Land South of Holt Road

Addendum to Design & Access Statement

December 2020

The revised parameter plan is also resubmitted as a standalone plan, ref 661B-27 Rev D.

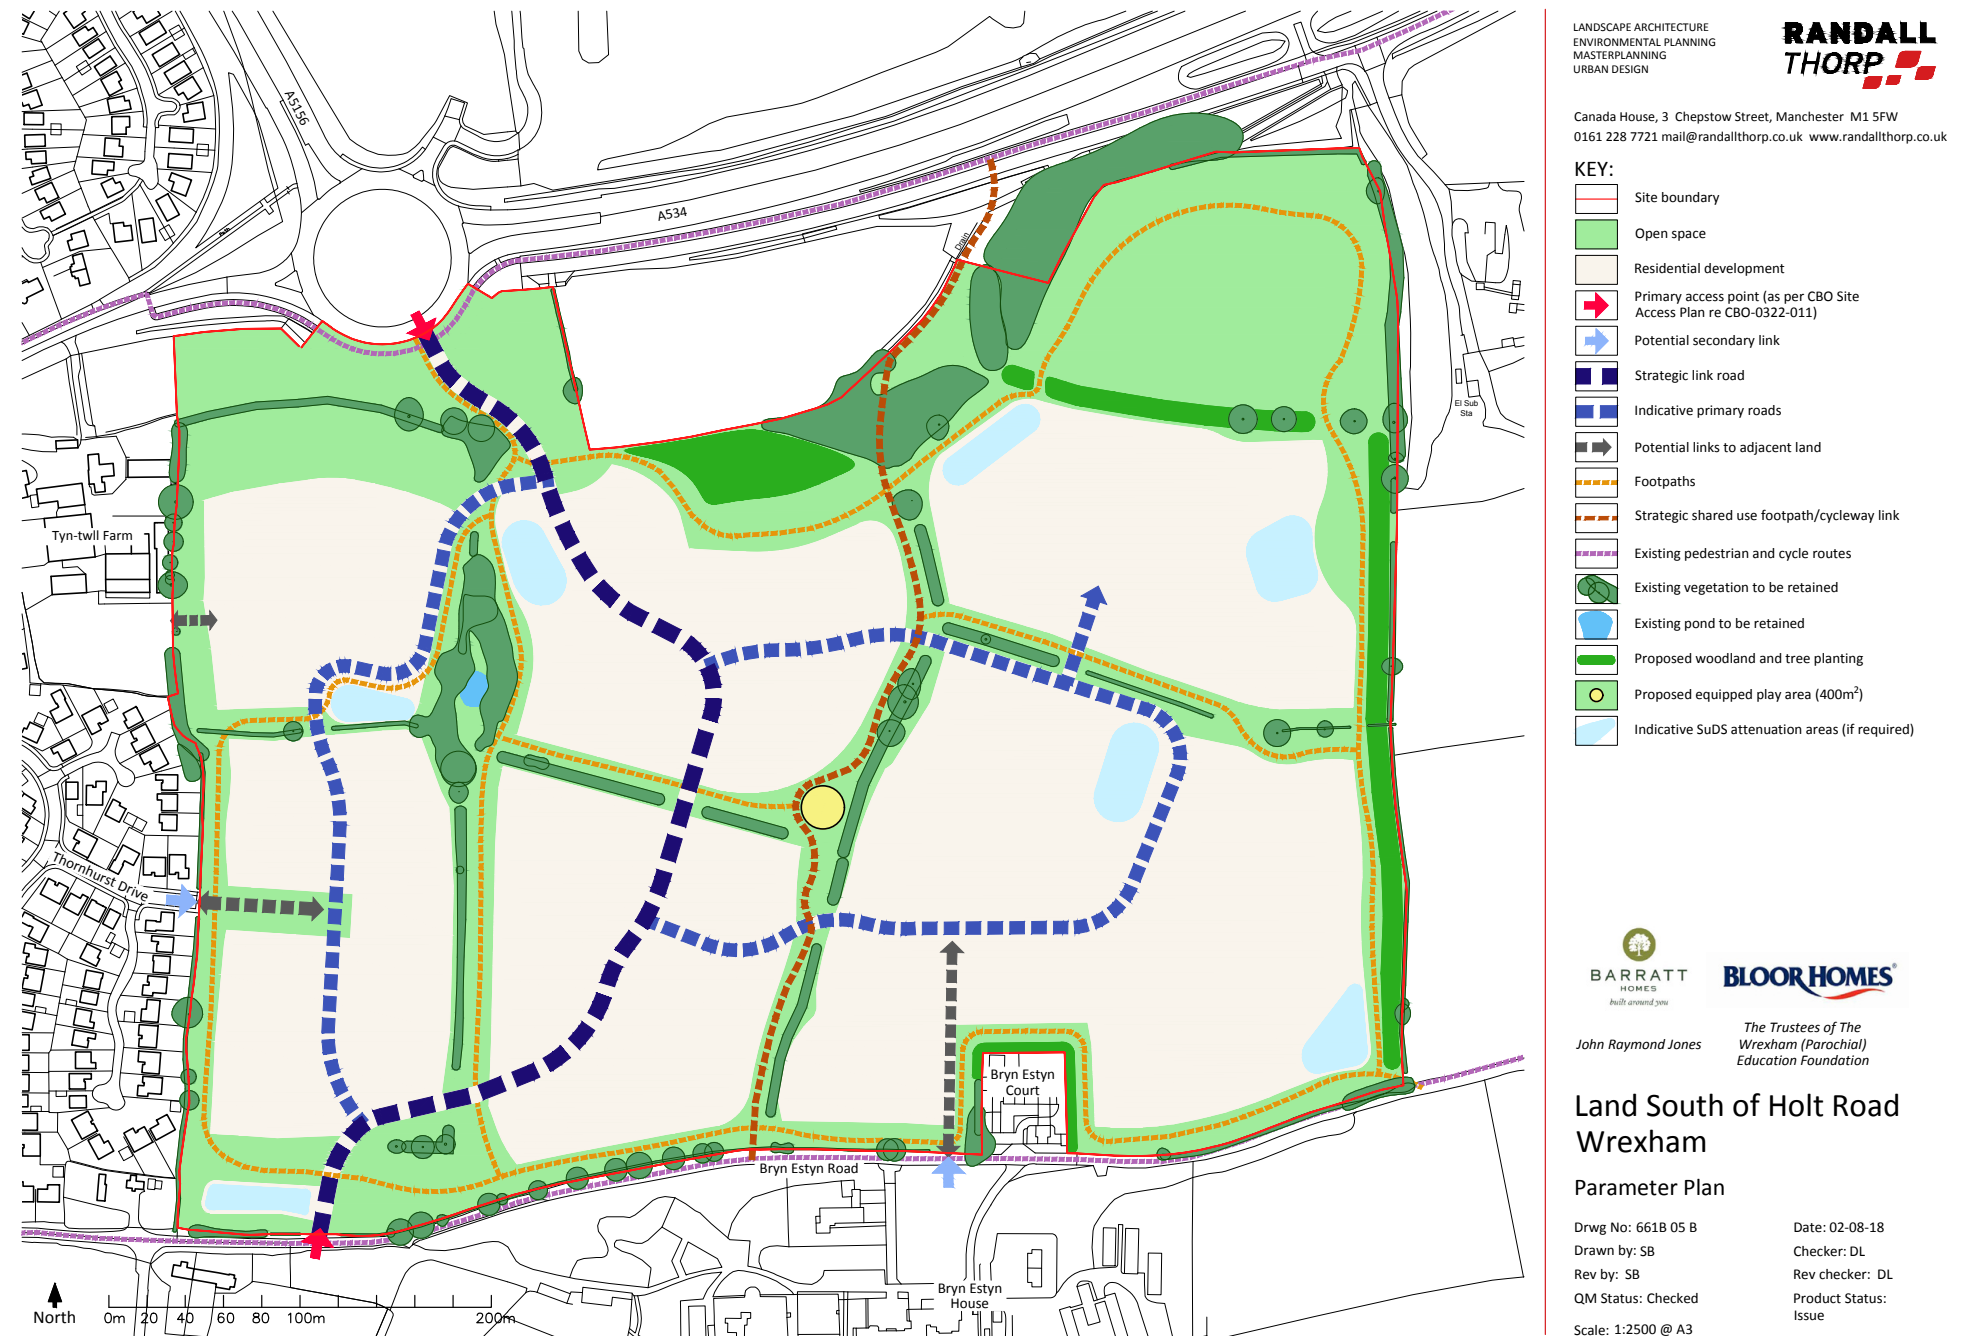
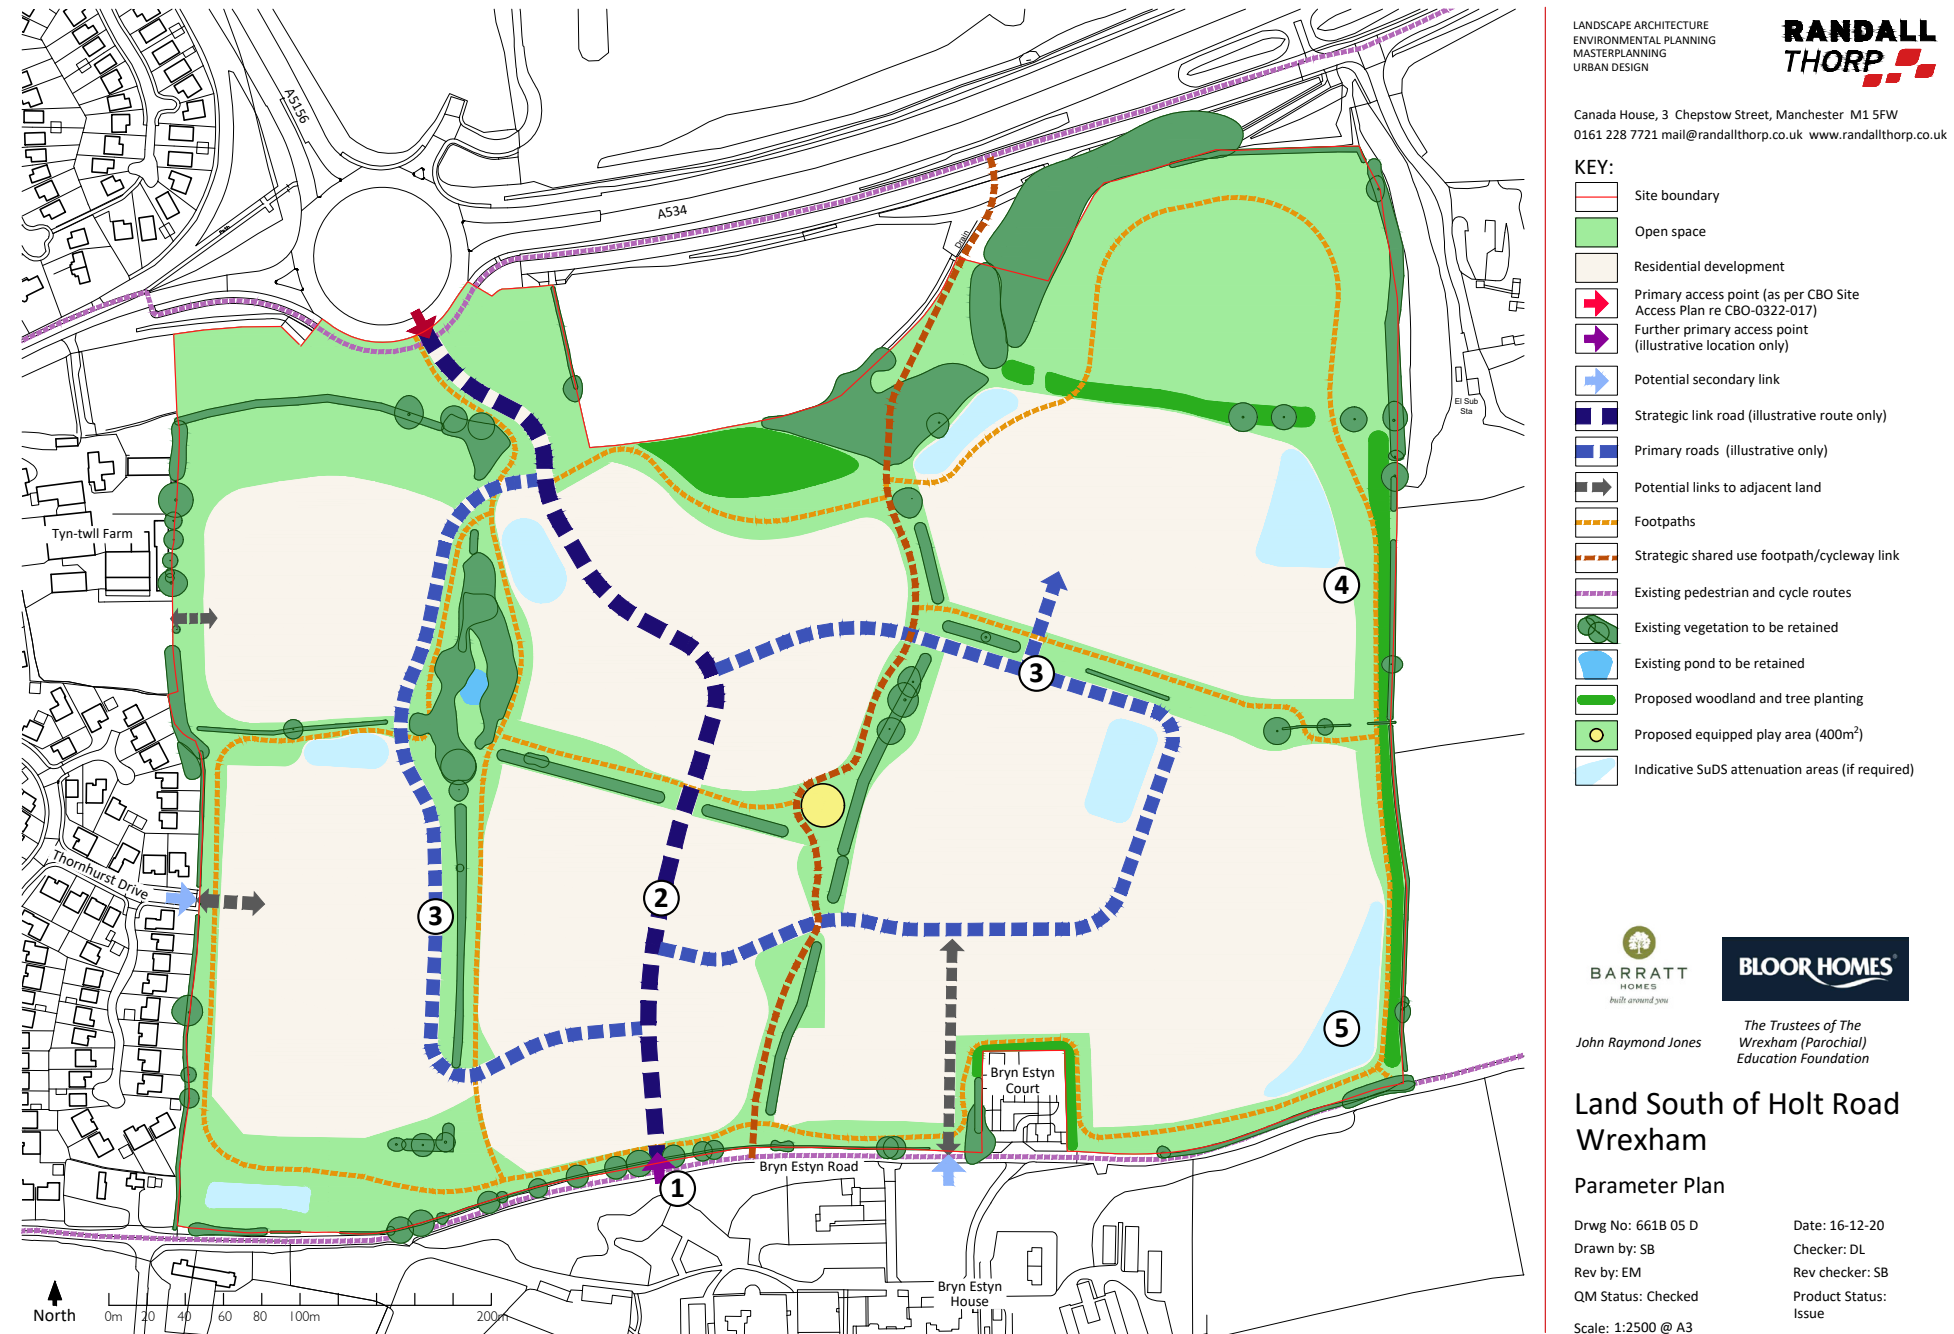
The revised parameter plan makes the following deviations from the submitted parameter plan:

1. Relocated access point along southern boundary off Bryn Estyn Road;
2. Revised strategic link road alignment as agreed with Wrexham Council;
3. Revised alignment of primary road network based on viability studies;
4. Slight modifications to extent of developable area; and
5. Revised SuDS attenuation areas following review by the design team.

The illustrative concept layout is also resubmitted as a standalone plan, ref 661B-04 Rev E.

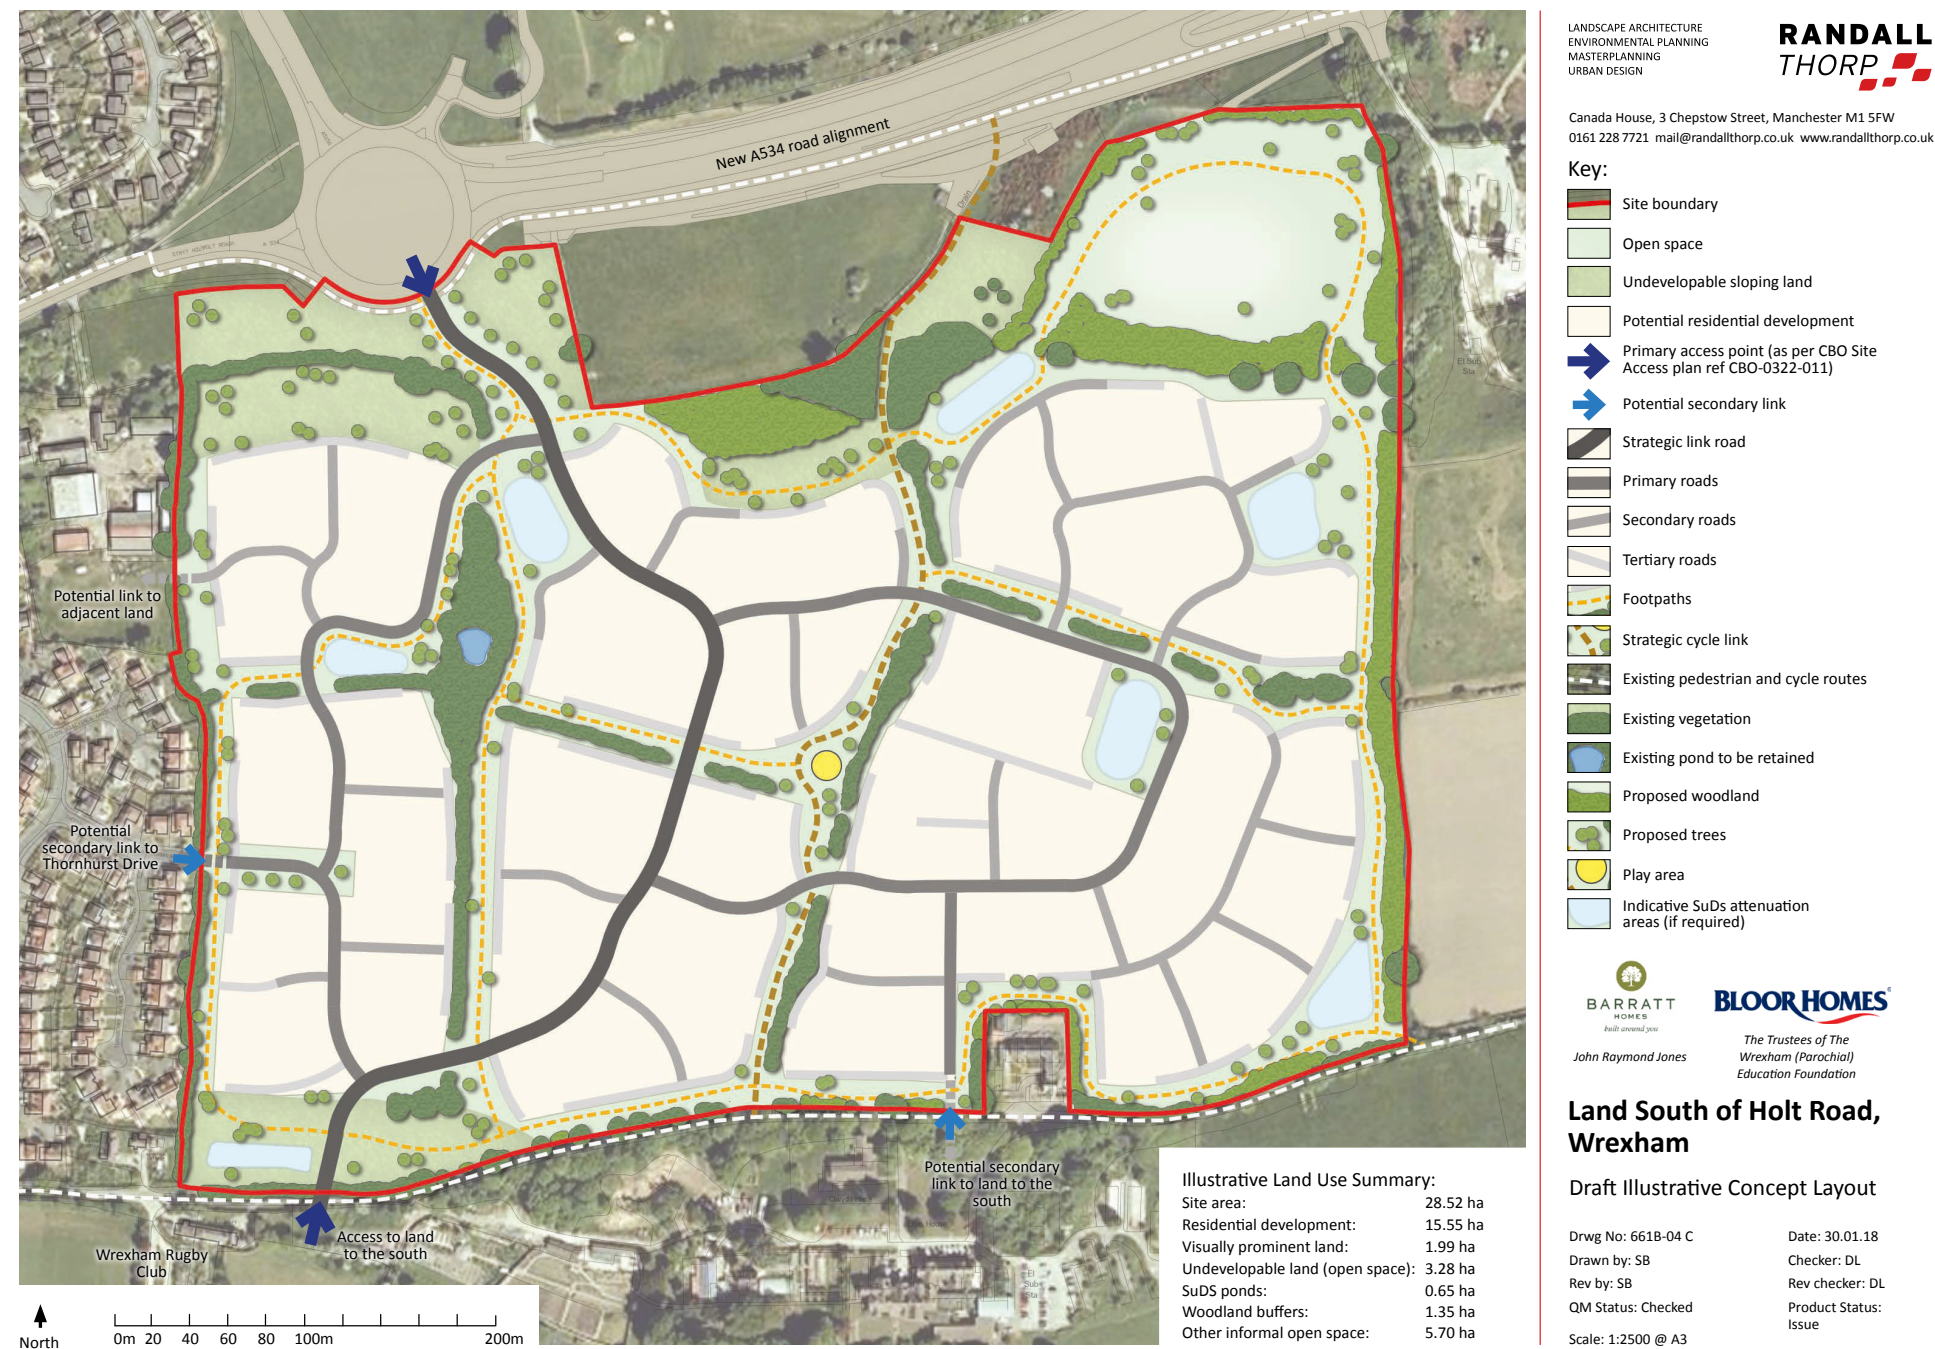
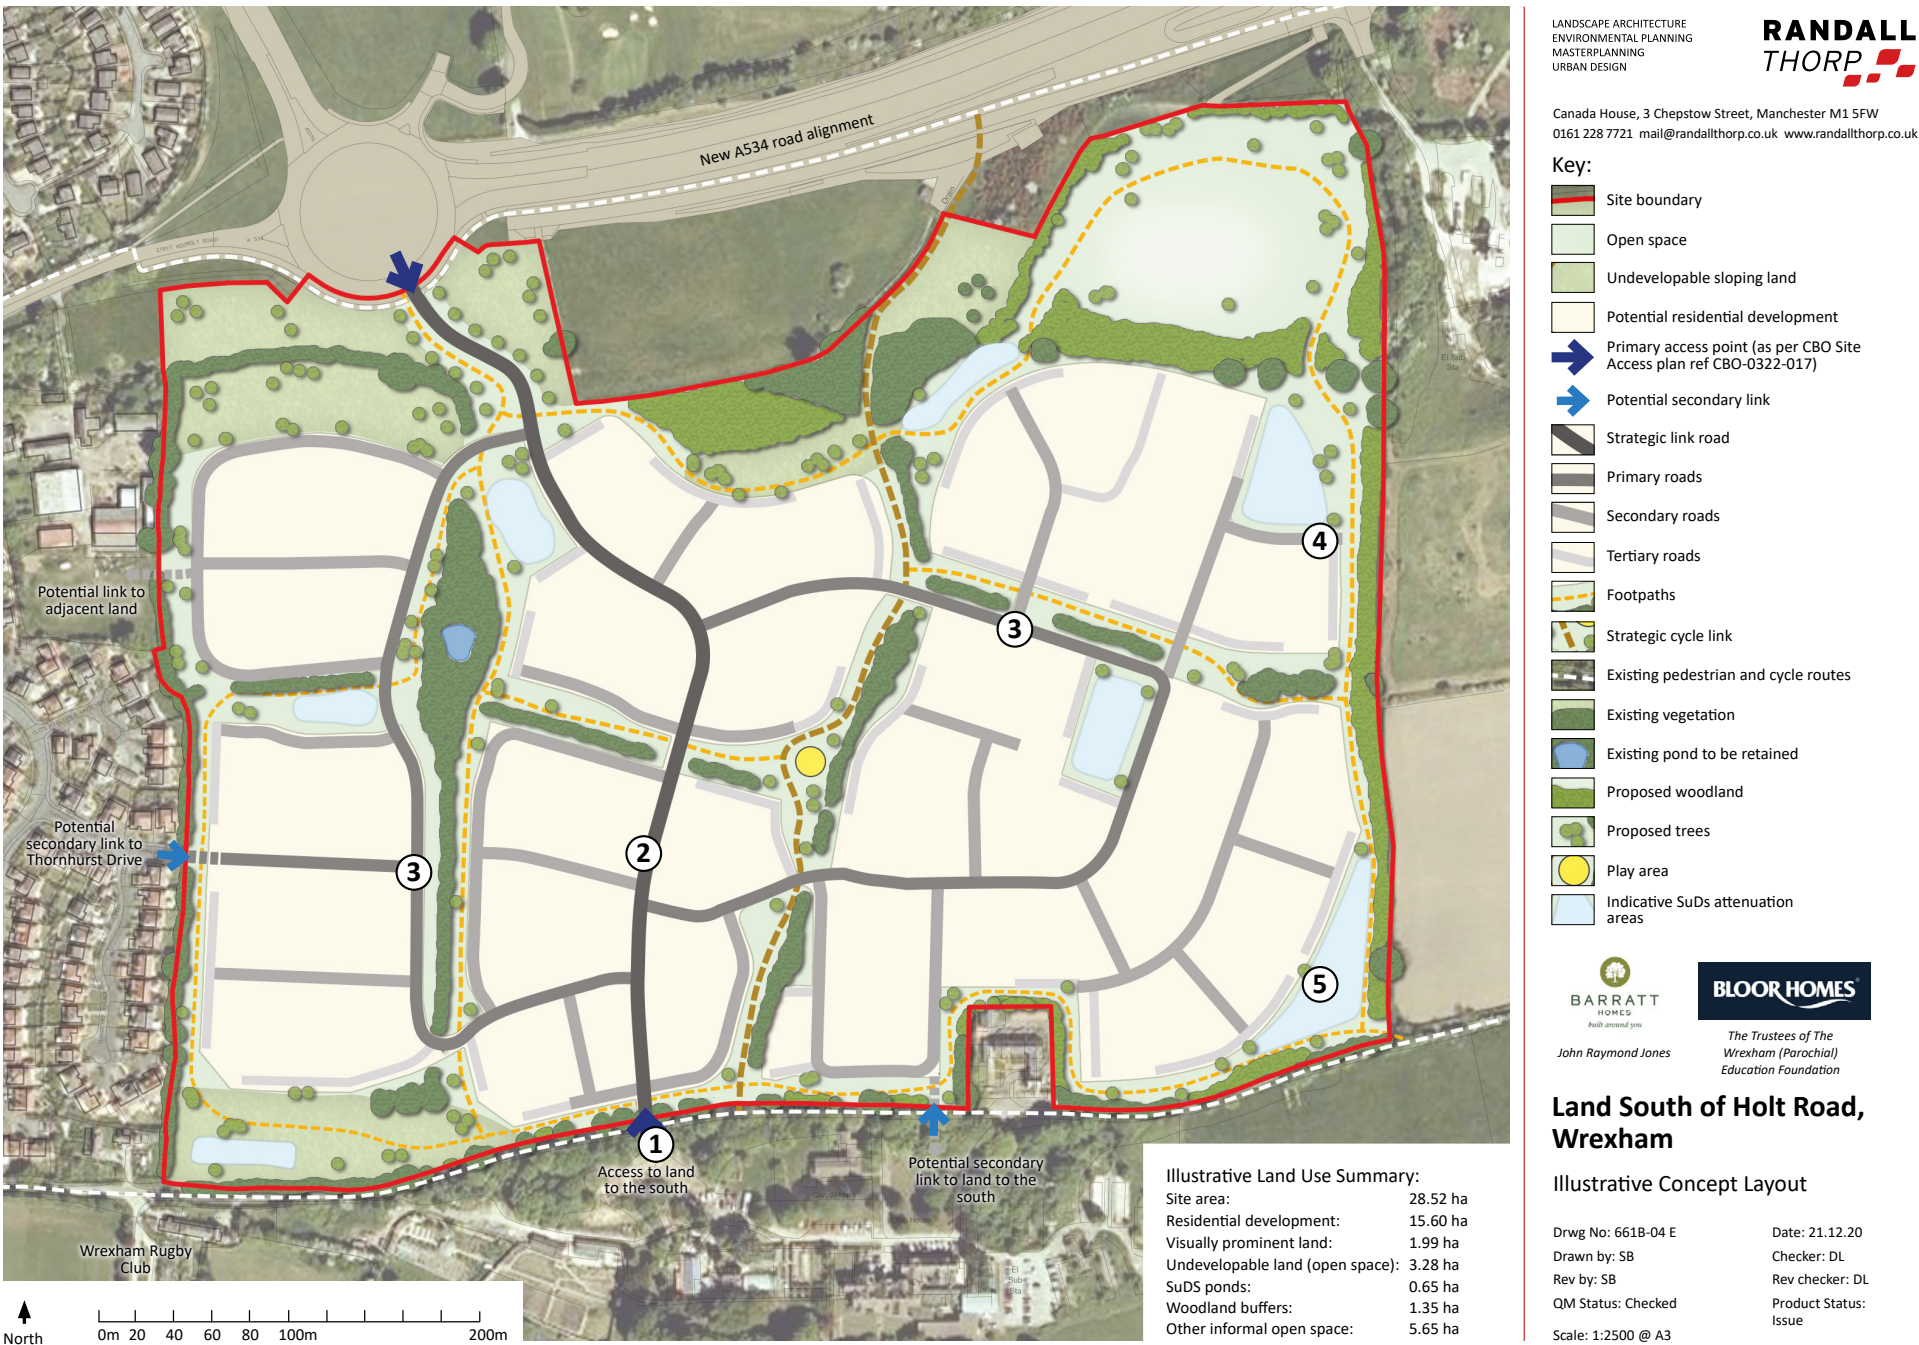
The illustrative concept layout has been updated in line with the revised parameter plan. The block structure and street network has been amended to align with emerging detailed housing layouts to provide an updated representation of how development may be brought forward, whilst according with the established masterplan principles and parameter plan.

As with the revised parameter plan, the main changes to the submitted plan include:

- 1.Relocated access point along southern boundary off Bryn Estyn Road;
- 2.Revised strategic link road alignment as agreed with Wrexham Council;
- 3.Revised alignment of internal road network based on viability studies;
- 4.Slight modifications to extent of developable area; and
- 5.Revised SuDS attenuation areas following review by the design team.
